**LEBANON PLANNING BOARD  
MARCH 8, 2021 - 6:30 PM  
REMOTE VIA MICROSOFT TEAMS  
LEBANONNH.GOV/LIVE**

**Agenda  
Planning Board  
March 8, 2021**

Staff Memorandum – PB2021-02-EXT – *continued from 2/8/21*

EXISTING CONDITONS & DEMOLITION PLAN FOR  
**OCCOM PATH - BASIC HOLDINGS, LLC**  
OAK RIDGE ROAD, CITY OF LEBANON, GRAFTON COUNTY, NH

ROADWAY AND STORMWATER DETAILS FOR  
**OCCOM PATH - BASIC HOLDINGS, LLC**  
OAK RIDGE ROAD, CITY OF LEBANON, GRAFTON COUNTY, NH

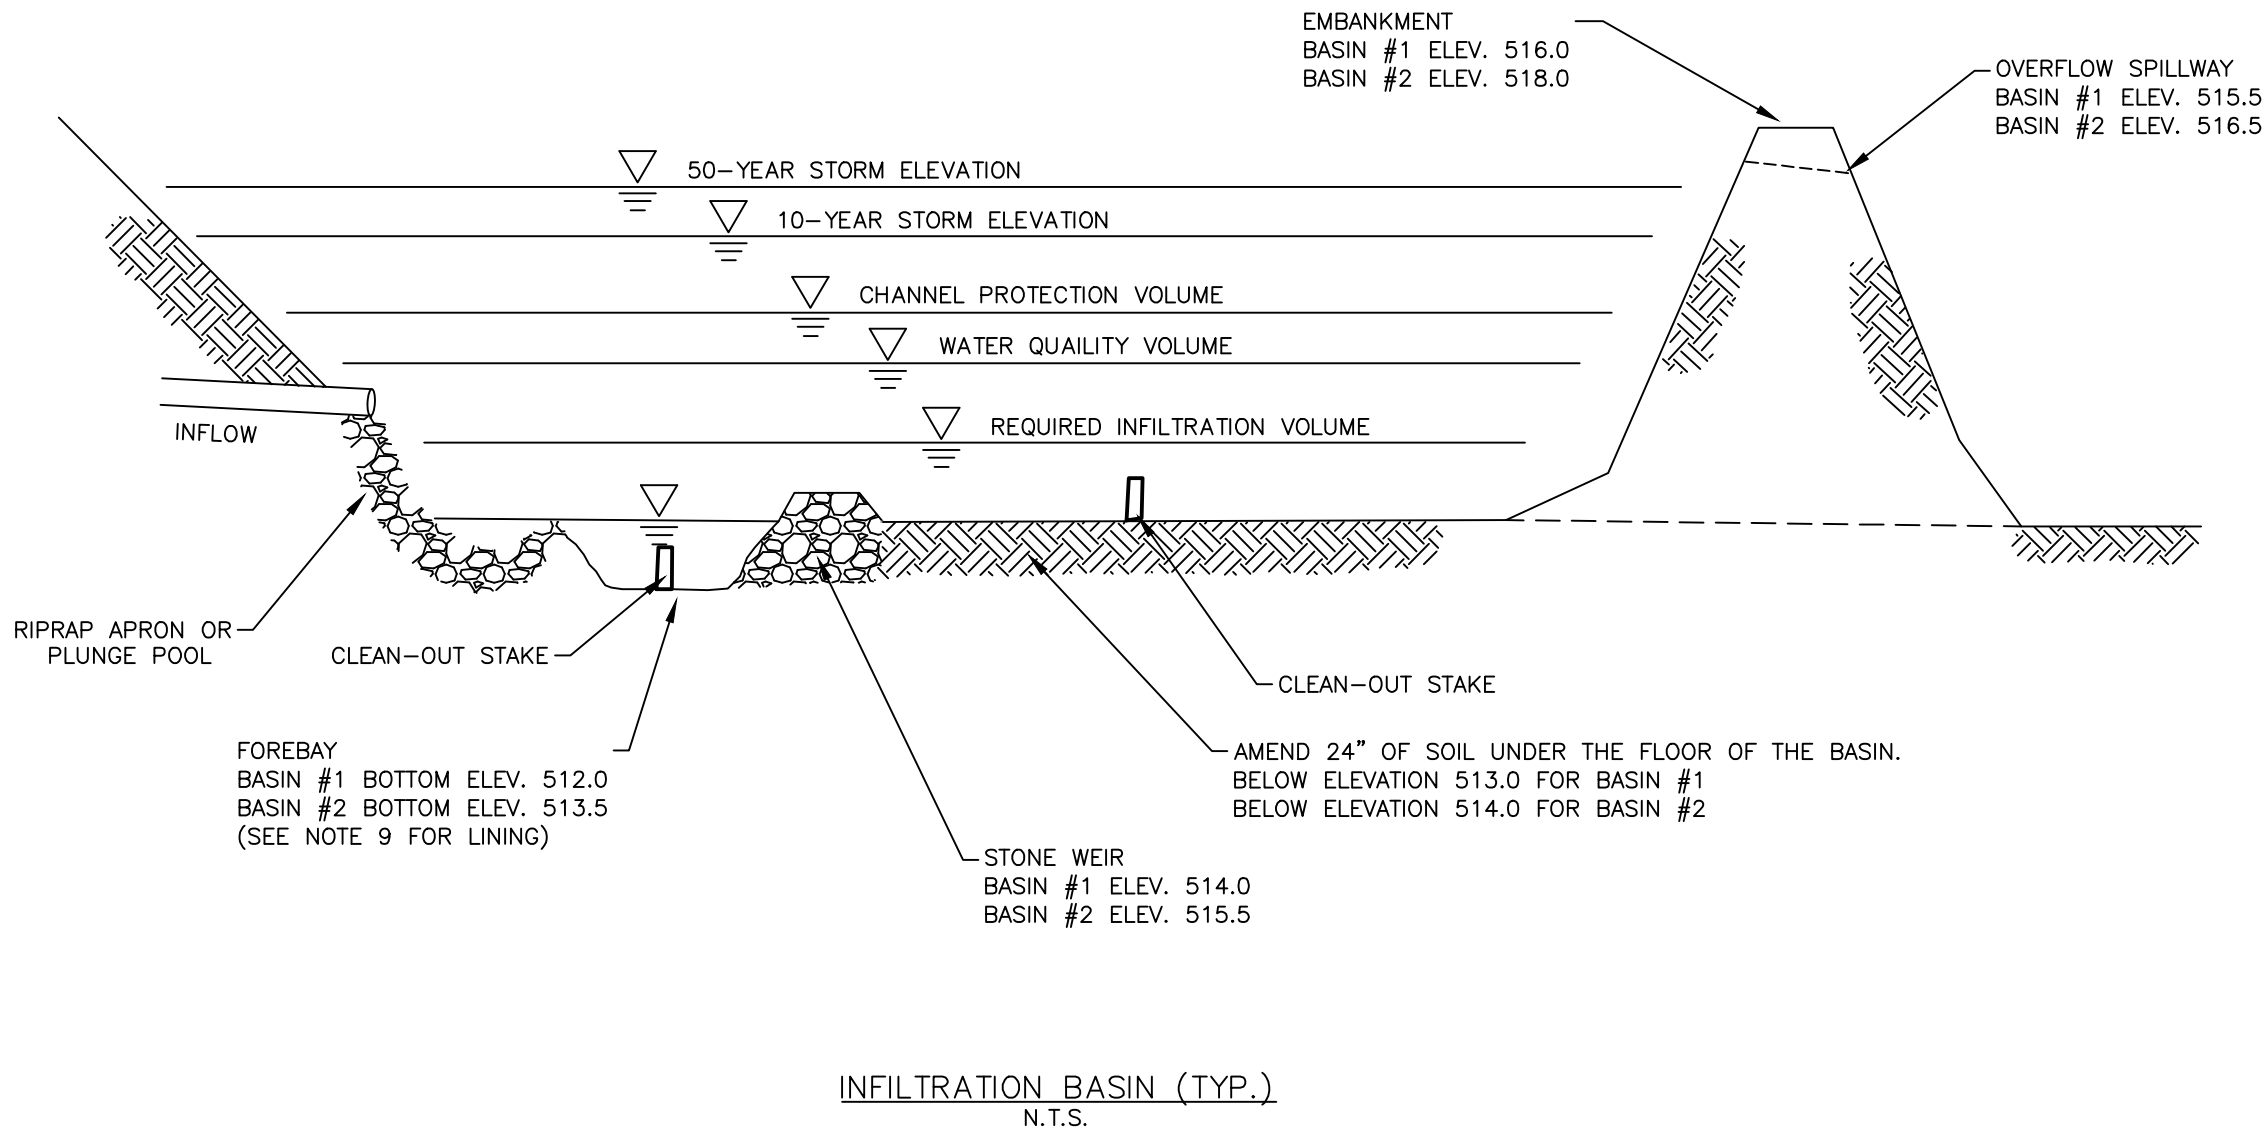
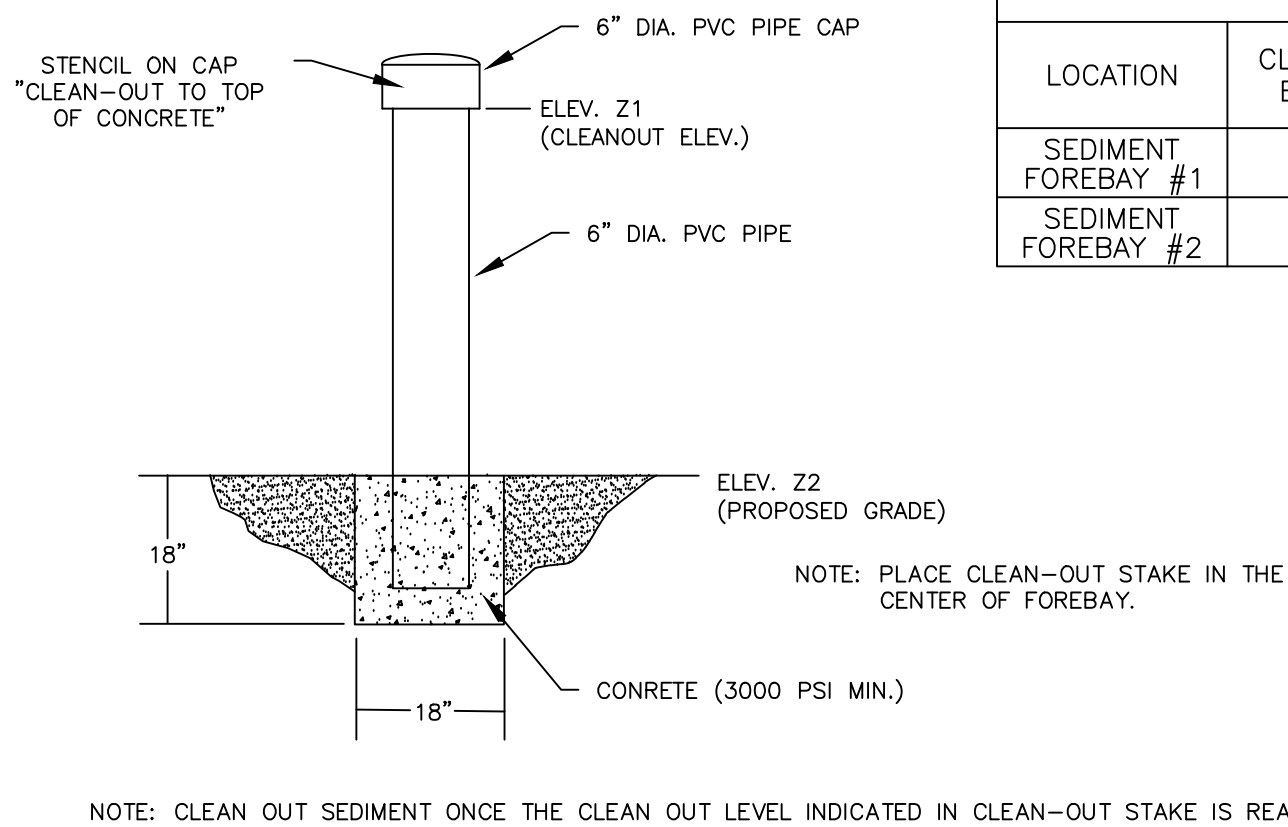
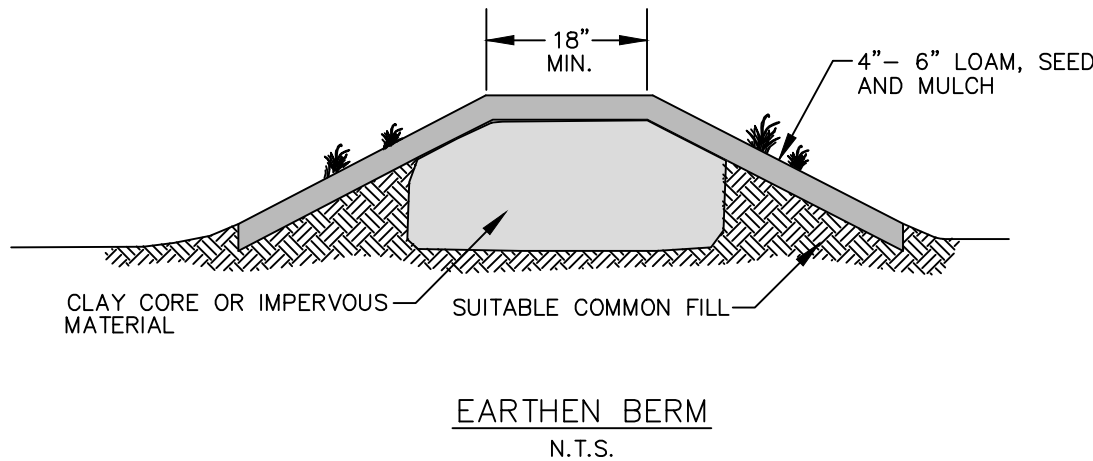
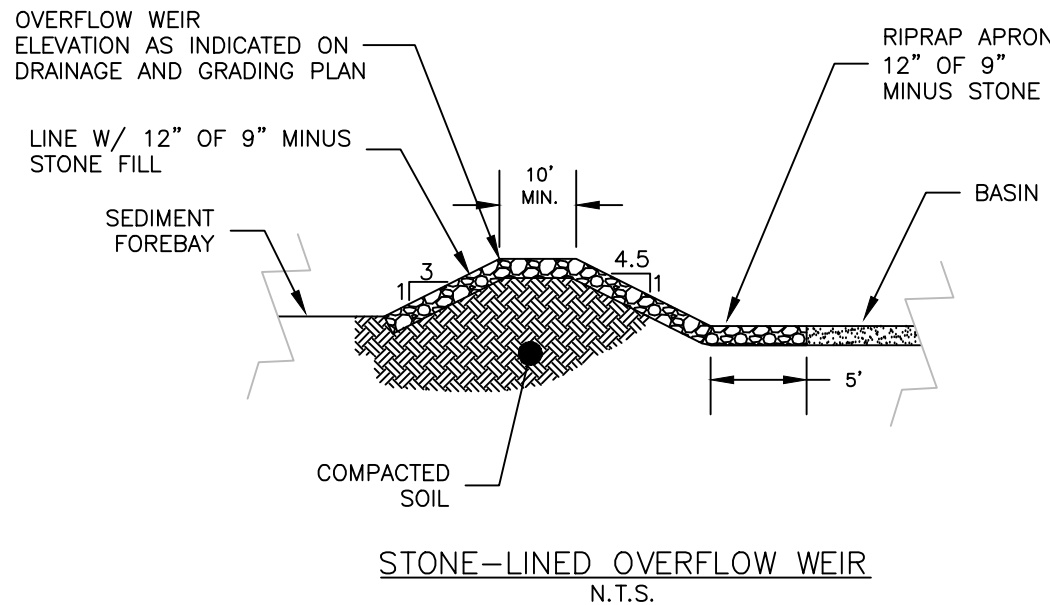
8. We recommend the typical Stone Discharge Apron detail provided on Sheet 13 be expanded to specify site specific dimensions and stone gradations for each application.

9. The project plans suggest all proposed storm sewer construction is to be completed with high density polyethylene (HDPE) pipe. If so, we recommend the typical Drainage Trench section provided on Sheet 13 be revised to specify corresponding pipe bedding and backfill requirements.

17. We recommend the Typical Road Cross-Section provided on Sheet 13 be revised or expanded as follows: (a) to specify typical centerline off-set dimensions for planned water, sewer, storm drainage and underground utility installations; (b) to specify accommodations for construction of graded gravel shoulders; and (c) to include a note specifying; "All workmanship and materials shall conform with Standard Specifications for Road and Bridge Construction, as published and amended by the NHDOT, as well as applicable requirements of the City of Lebanon".

15  
SHEET 15 OF 17

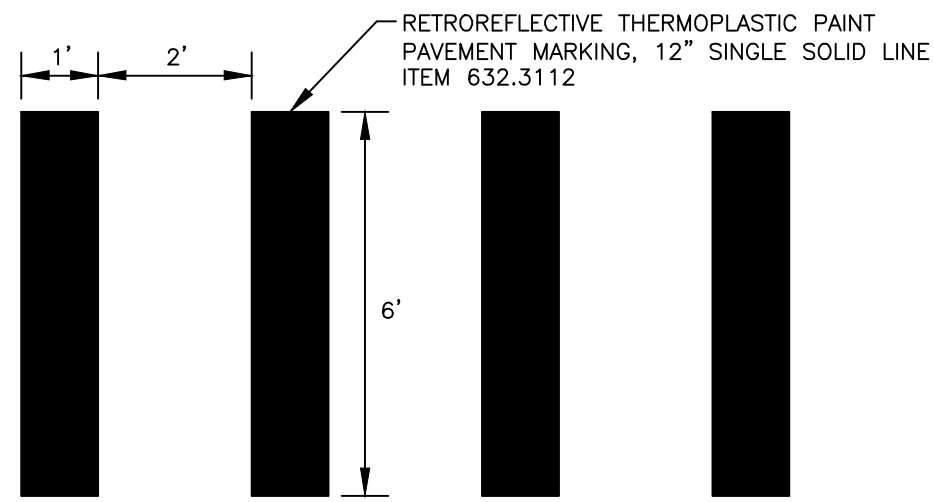
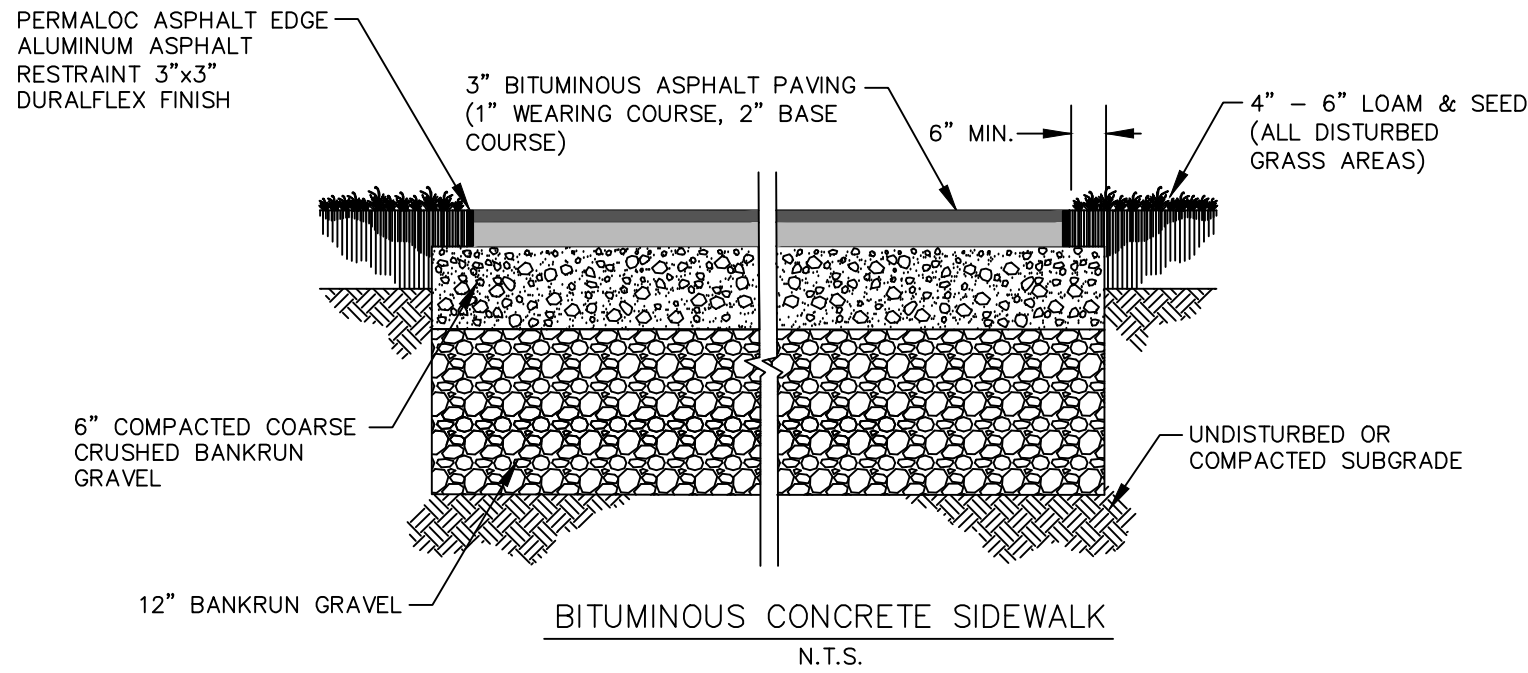
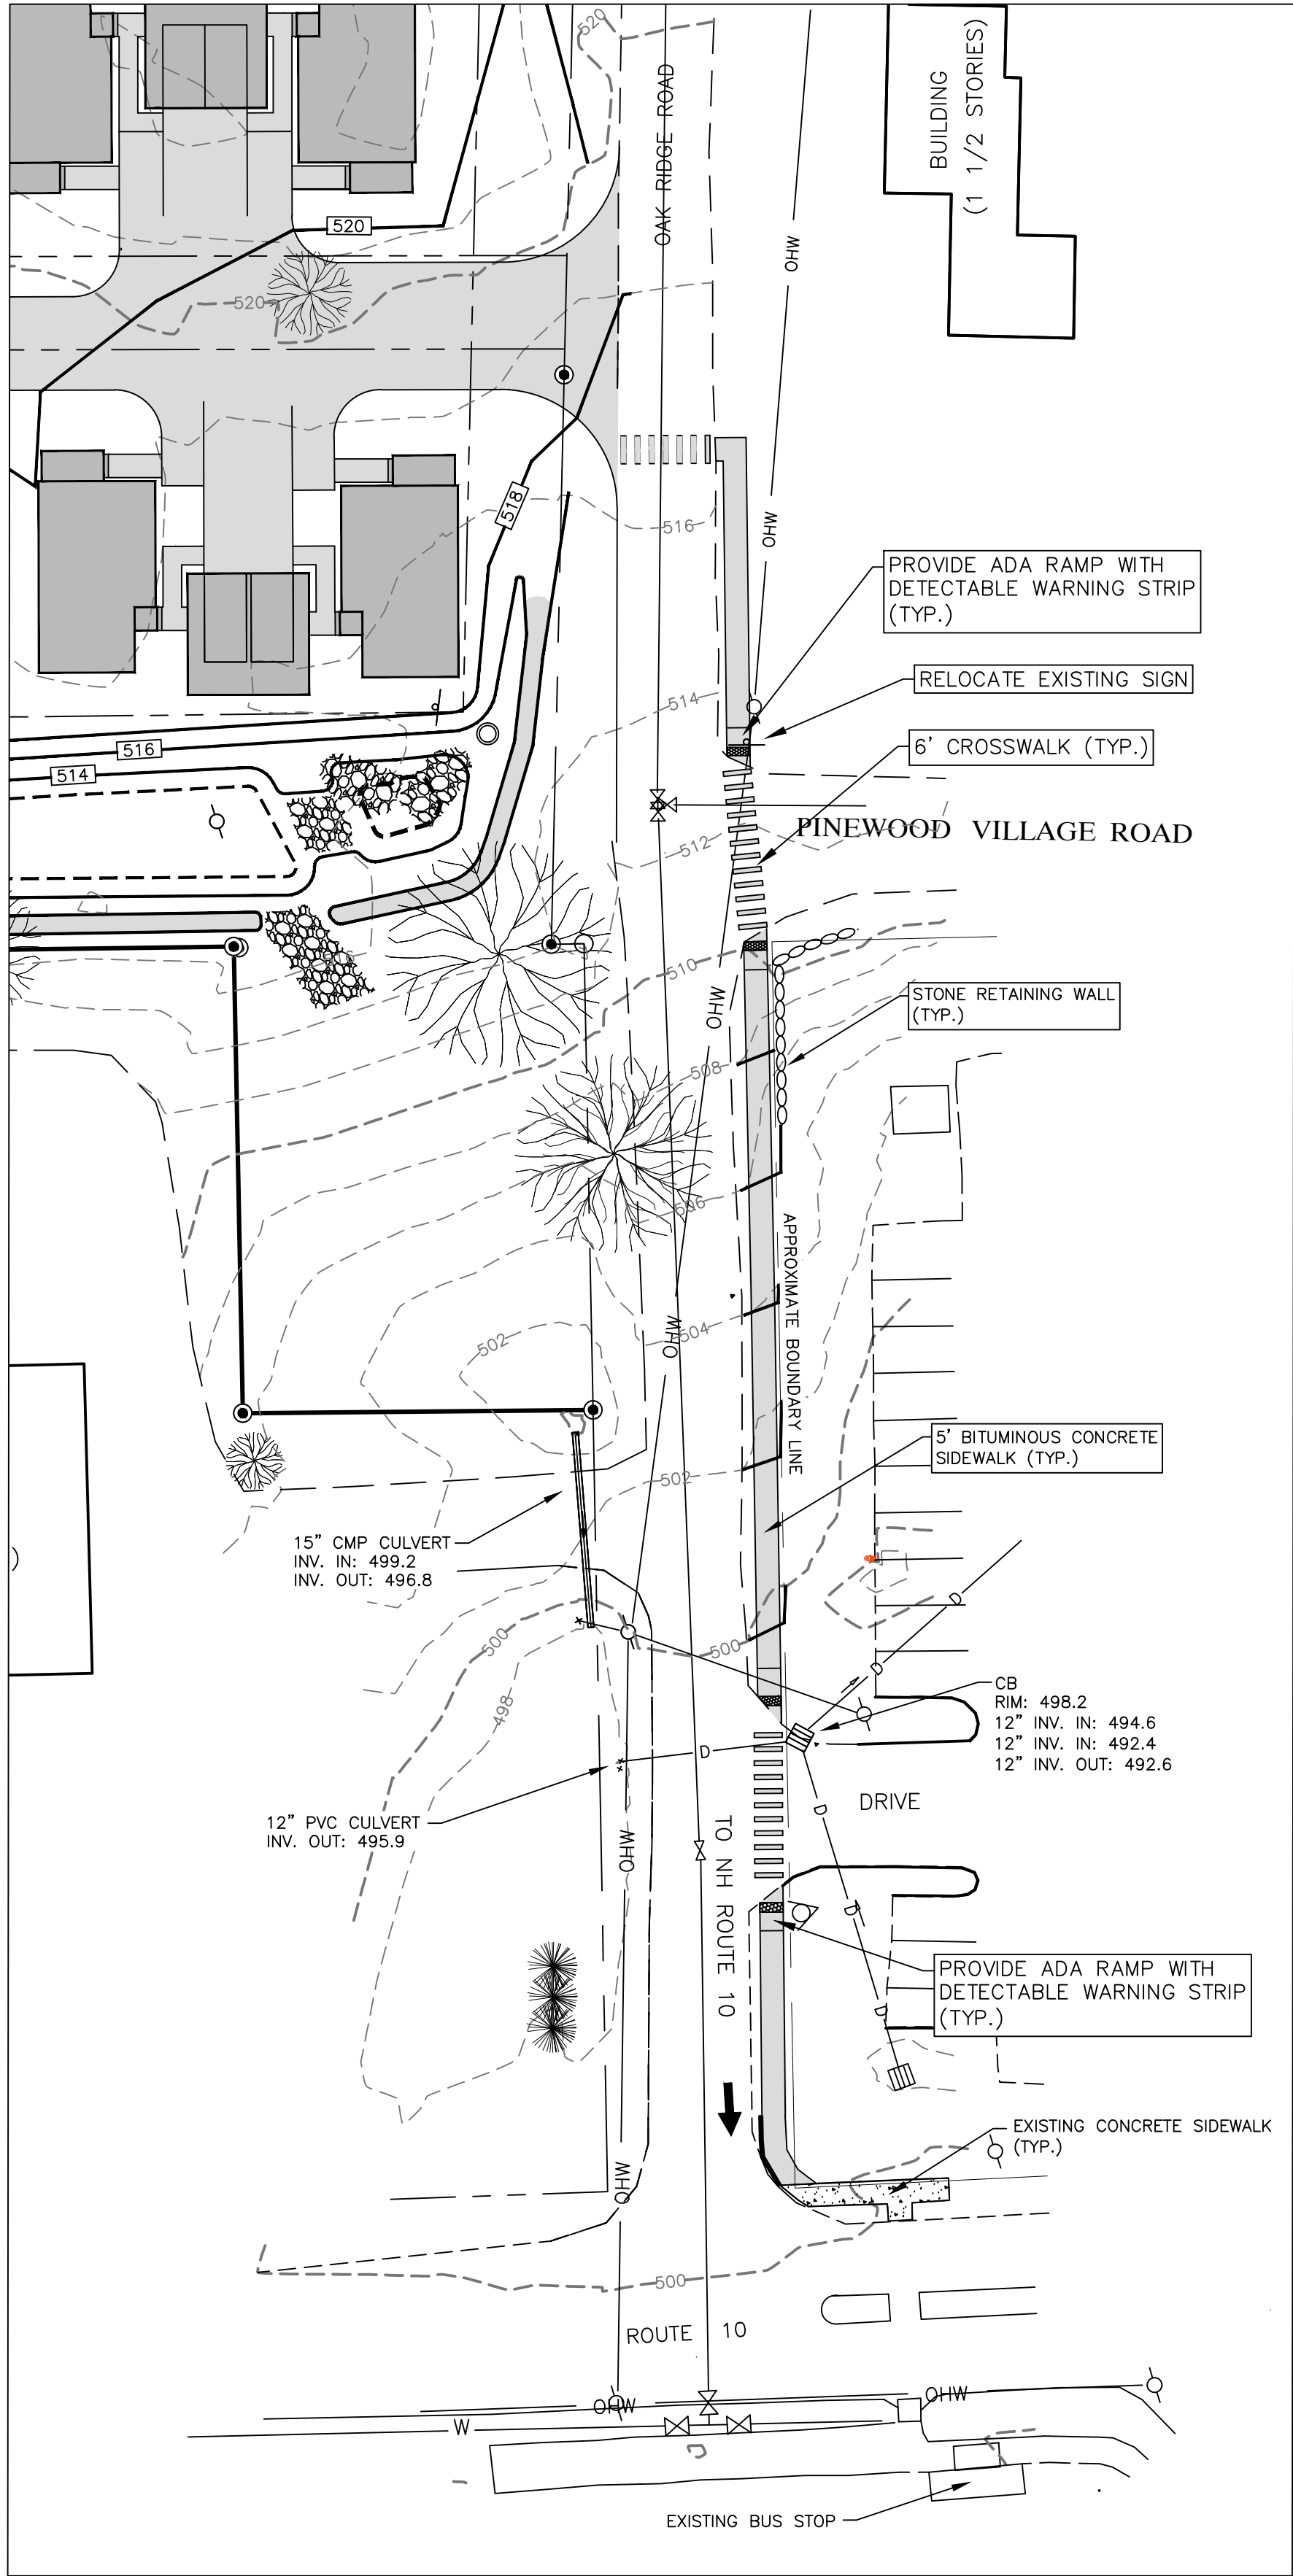
18. Sheet 15 depicts the intent to construct a segment of future public sidewalk along the northerly line of Oak Ridge Drive to the east of the planned site driveway. Based upon our review of this drawing we offer the following remarks:
